M54 to M6 Link Road
TR010054
Volume 8
8.7 Consultation Statement – Proposed
Scheme Changes

8.7 Consultation Statement – Proposed Scheme Changes Appendices Part 1 (B and C)

M54 to M6 Link Road CONSULTATION ON PROPOSED CHANGES TO THE DEVELOPMENT CONSENT ORDER APPLICATION 24 AUGUST 2020 TO 23:59 21 SEPTEMBER 2020

C1 Proposed Changes Consultation Brochure

C2 Environmental Masterplan

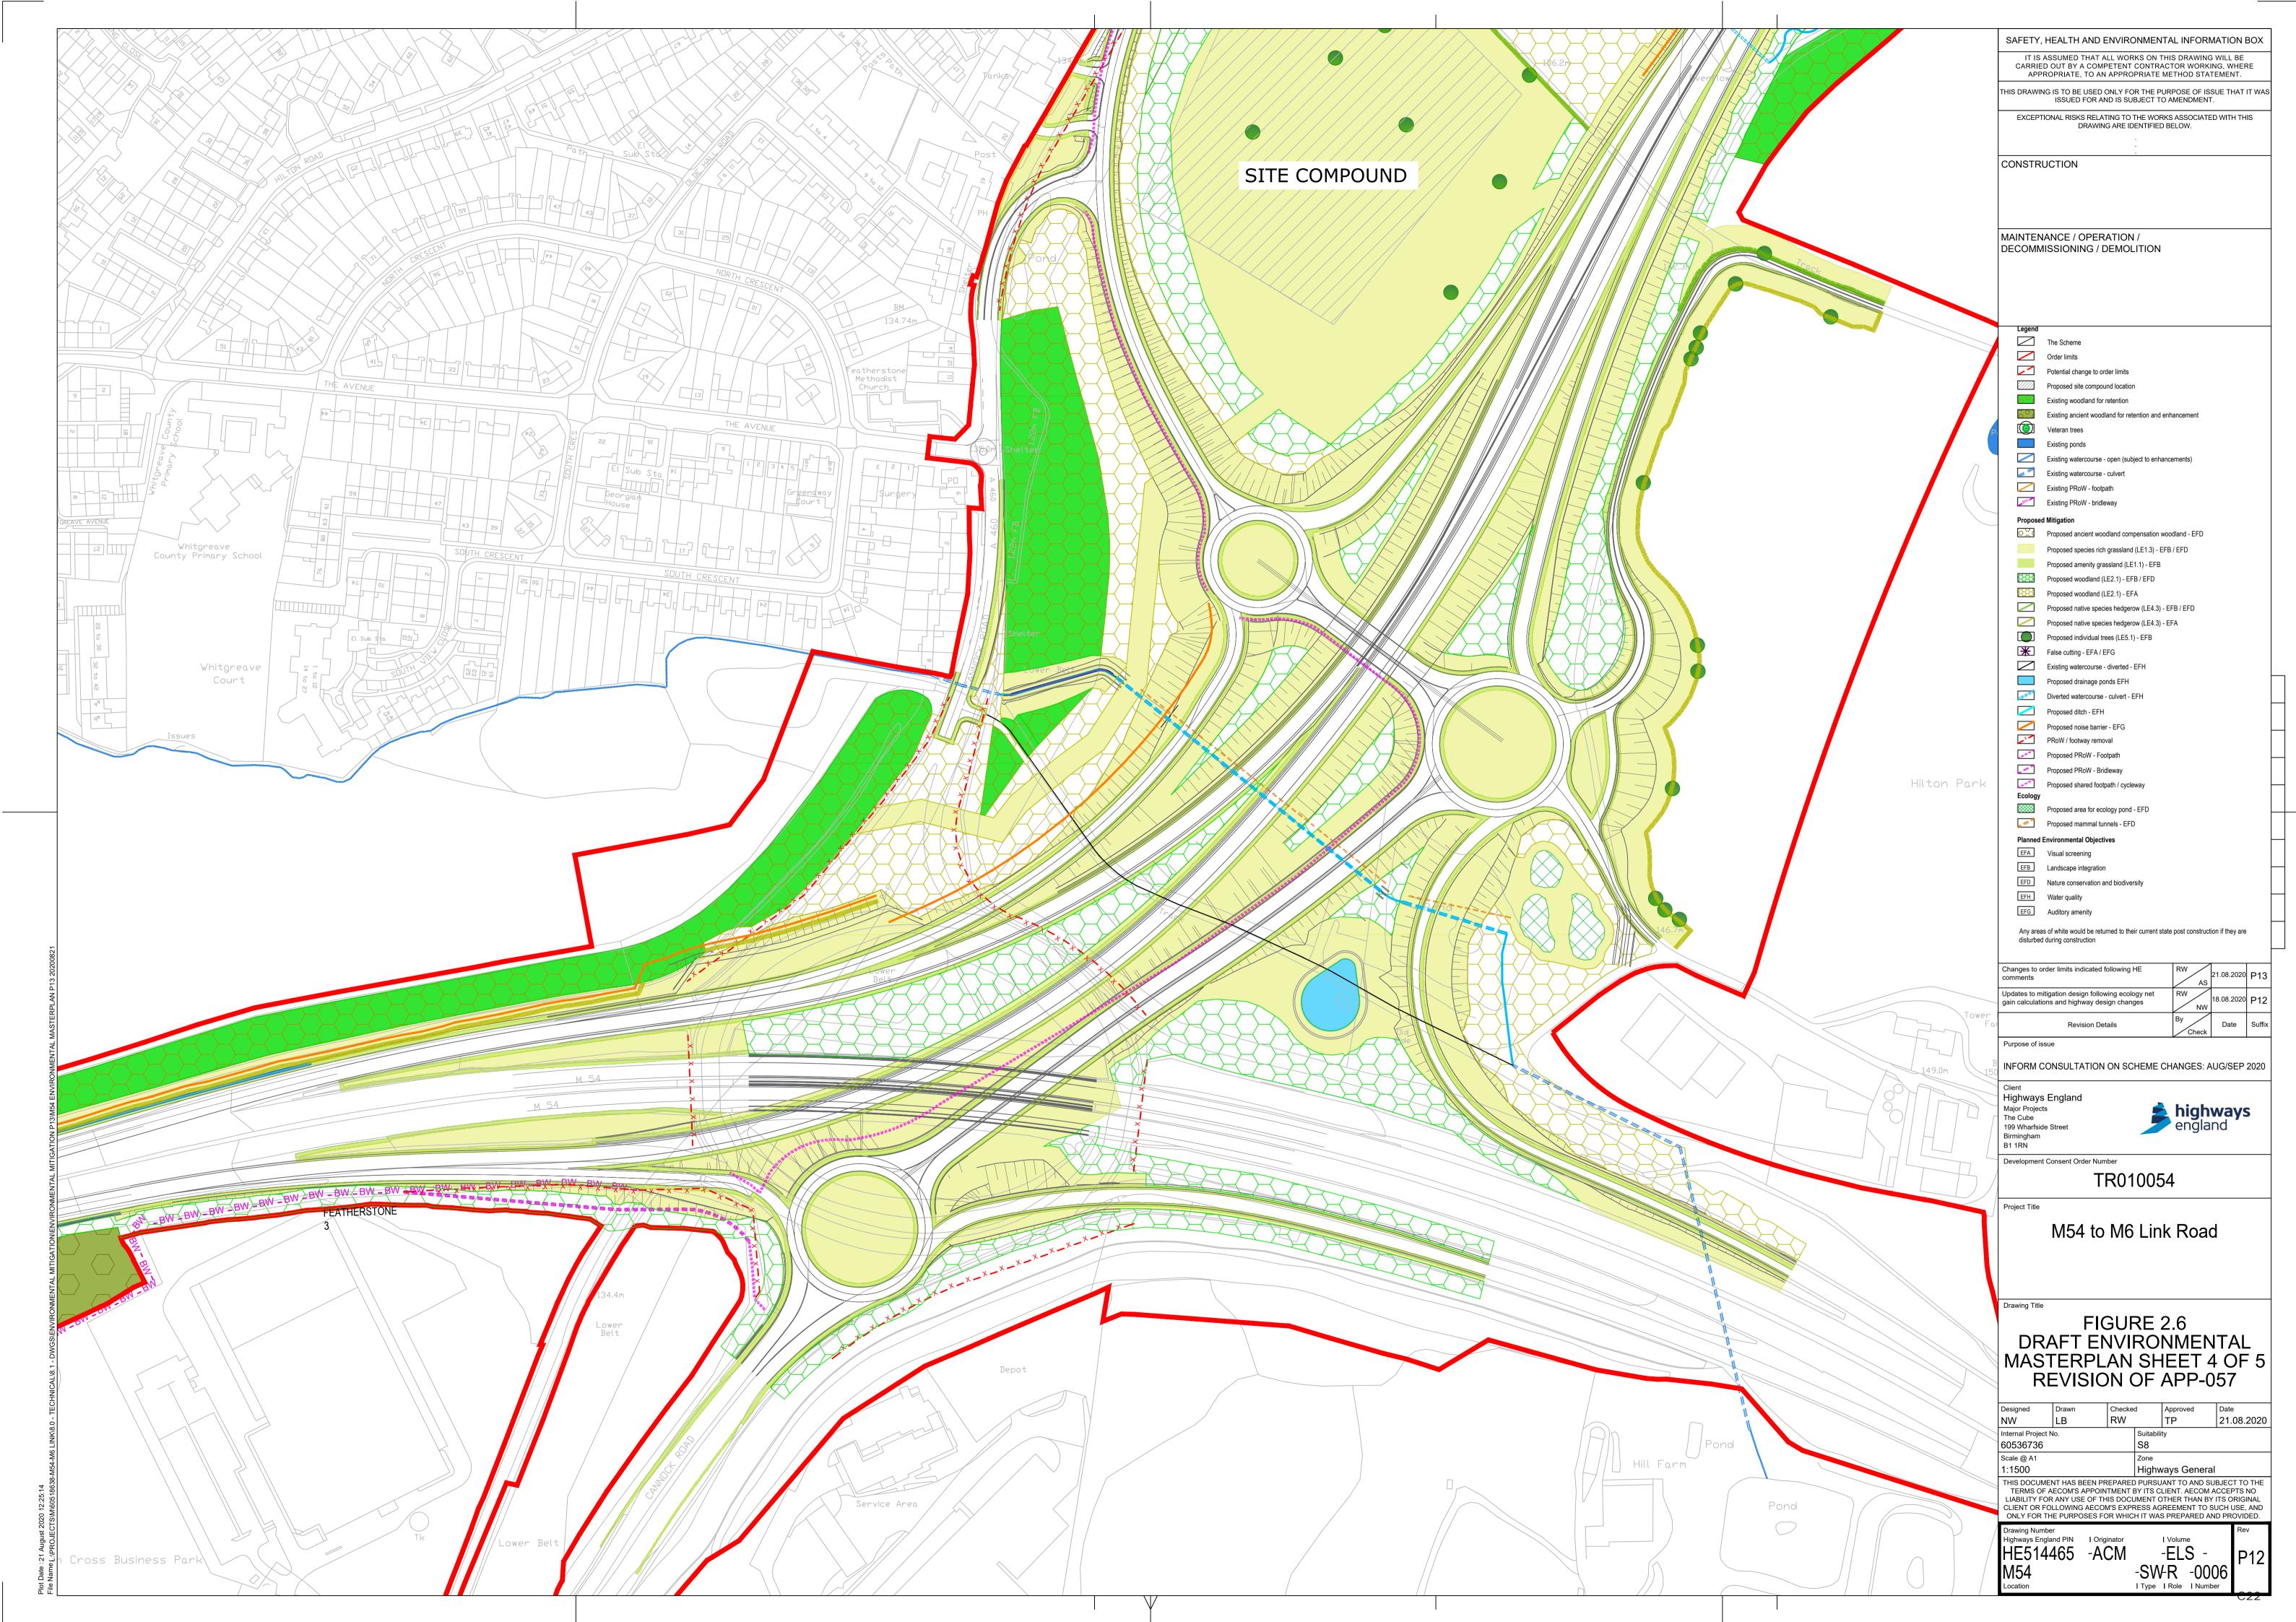
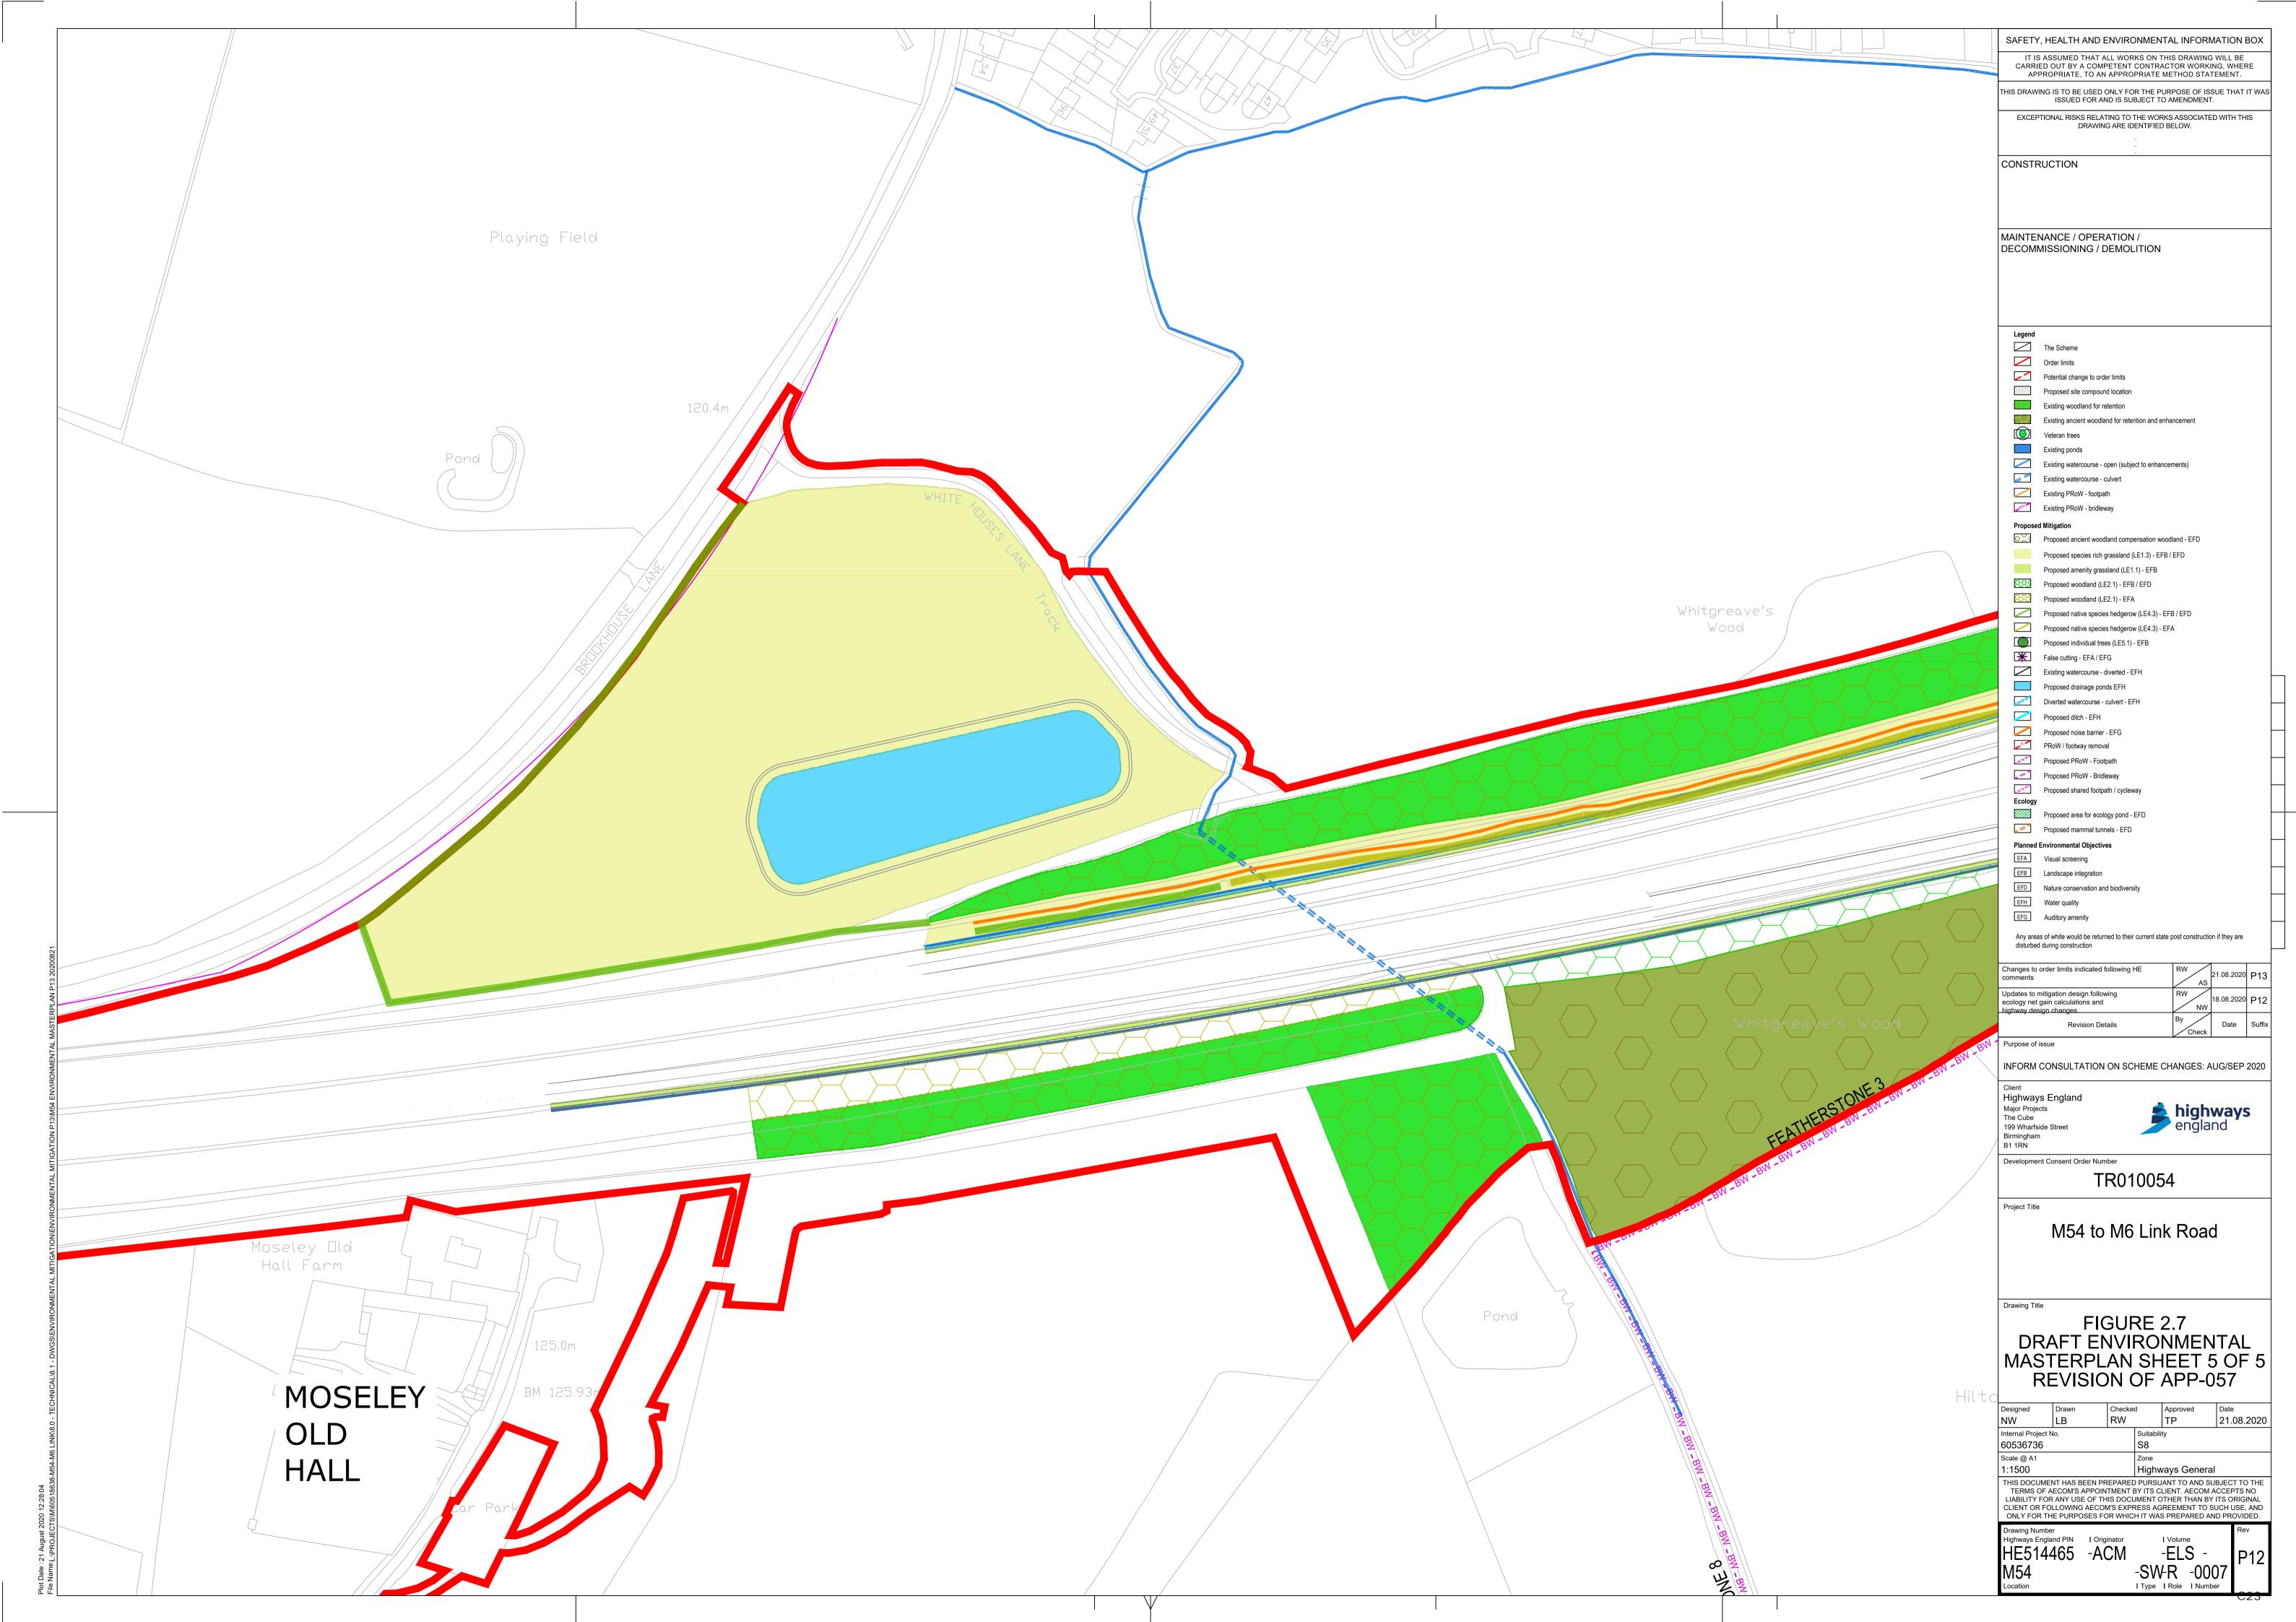
Figure Ref	Change to Masterplan	Why we are proposing the change	Implications of the Change
EM1	Reduction in the size of the construction compound to the north west of Junction 11.	The size of the compound area has been reviewed with the contractor to reduce the impact on existing habitat. This has involved detailed consideration of the plant and material storage requirements to ensure that the revised compound area is sufficient. This process has resulted in a reduction in the size of the site compound and a reduced impact on existing habitats.	Reduction in site compound area reduces the impact on existing habitats and consequently overall mitigation requirements. One pond rather than two would be developed on the land. Part of this land will be used temporarily as a
EM2	Removal of one ecology pond which was proposed as great crested newt (GCN) mitigation.	Two ecology ponds were proposed to compensate for the one that would be lost during construction, assumed to contain GCN. This was in line with mitigation agreed with Natural England. The pond to be lost was found to not support GCN during 2020 surveys. Therefore, one pond previously proposed has been removed and only one ecological mitigation pond is required in this location.	construction compound, before being reinstated and used for habitat creation. This whole land parcel is still required permanently to mitigate the ecological impact of the scheme. This includes creation of the new pond in the south western corner of the land parcel to compensate for the loss of the existing pond.

EM3	Removal of proposed species rich grassland to the south east of M6 Junction 11.	The scheme changes reduce the impact of the scheme on ecology due primarily to a reduced footprint. The extent of mitigation has been fully reviewed. This location is Best and Most Versatile (BMV) agricultural land, with high quality soils capable of consistently producing moderate to high yields of a narrow range of arable crops. Natural England requested that the loss of BMV land be reduced wherever possible. Transforming this parcel into species rich grassland by inverting/scarifying the topsoil to bring the less nutrient rich subsoil to the surface would be in opposition to the need to retain BMV land. Consequently, it is proposed to remove the proposed habitat creation from the land parcel.	Reduced loss of BMV land. This land would no longer be permanently acquired. The northern part of this land parcel will still be acquired temporarily during construction for topsoil and earthworks storage, before being reinstated to its previous condition and returned to the landowner. The southern part of the land parcel would no longer be required for the scheme. The DCO limits would be amended to remove the southern portion of the land parcel from the application.

EM4	Additional hedgerows in the north of the scheme.	Opportunities have been identified for additional hedgerow creation to provide additional biodiversity enhancements.	Ecological enhancements incorporated into the scheme. New hedgerows have been placed in areas that would be required permanently for environmental

Figure Ref	Change to Masterplan	Why we are proposing the change	Implications of the Change
			mitigation, so no additional land acquisition is required.
EM5	Reduction in woodland planting in the area between Park Road and Hilton Lane.	The changes to the scheme have reduced the loss of woodland as part of the scheme, including reduction of loss of ancient woodland, where compensatory planting had been agreed at a ratio of 7:1. As a consequence, less woodland planting is required to mitigate the impact of the scheme.	Reduced new woodland planting as there is less woodland loss. The area of the field permanently acquired would be significantly reduced. A border around the site is still required for permanent acquisition for essential mitigation to mitigate the landscape and visual impact of the scheme. Mitigation to the south east and south west is also still required to mitigate for habitat loss and the impact on Protected Species at Lower Pool and surrounding area. However, the area shown in white would only be required temporarily. The whole area is required temporarily during

EM6	Removal of three ecology ponds and wet grassland that were proposed as GCN mitigation.	This habitat was proposed to provide a receptor area for GCN assumed to be present in ponds to be lost during the construction of the scheme. These ponds were found not to support GCN during surveys in 2020, therefore the receptor area is no longer required.	construction of the scheme for use as a borrow pit. Reduction in habitat creation due to more accurate knowledge of species on the site. Reduced permanent and temporary land acquisition. Part of this land parcel will still be required permanently to provide woodland planting to screen views of the scheme. A sliver of land to the south of Dark Lane would also be required to upgrade the fence on the highway boundary. The remainder of this land parcel will no longer be required and would be removed from the DCO limits.
ЕМ7	Reduction in the size of the southern construction compound to the east of Featherstone.	The size of the compound area has been reviewed with the contractor to aim to reduce the impact on existing habitats. This has involved detailed consideration of the plant and material storage requirements to ensure that the revised compound area is sufficient.	Reduction in impact on existing habitats. This land parcel is required permanently for environmental mitigation and will be used temporarily during the construction phase as a construction compound and for topsoil and earthworks storage. There would be no change to land acquisition.

EM8	Repositioning of individual trees.	Individual trees proposed to the south of the scheme within the boundary of Hilton Park have been repositioned in line with Ordnance Survey 1st edition map (1900 – 1902).	The land will still be permanently required for environmental mitigation.

Figure Ref	Change to Masterplan	Why we are proposing the change	Implications of the Change
EM9	Removal of a strip of woodland along the length of utilities diversion.	Removal of woodland and tree planting within 6 metres of the proposed utilities diversion. This has been replaced with a strip of species-rich grassland.	This land will still be permanently required for the utilities diversion and environmental mitigation but small areas of planting have been removed.
